Please find the responses to all three reviewers in this document.

Review of “A self-sufficient mobile broadband seismological recording system for year-round operation in Antarctica” by A. Eckstaller et al., 2022, Geoscientific Instrumentation

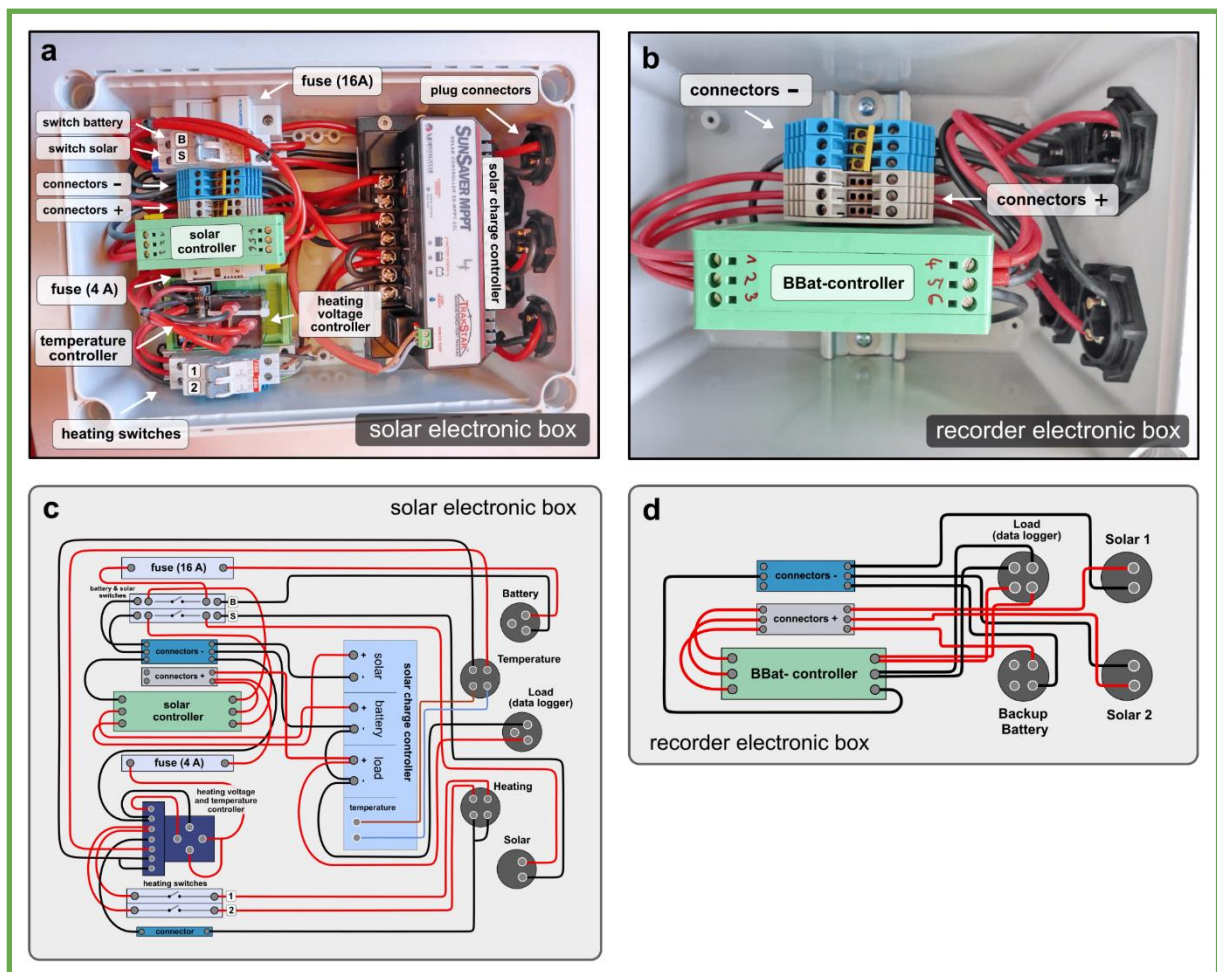
Section 3.1.1 and 3.2- I think more details are needed (wiring diagrams?) for these sections to be helpful to the reader or an engineer.

This is a very good suggestion. We now complement Figure 4 with two wiring diagrams for the solar electronic box and recorder electronic box.
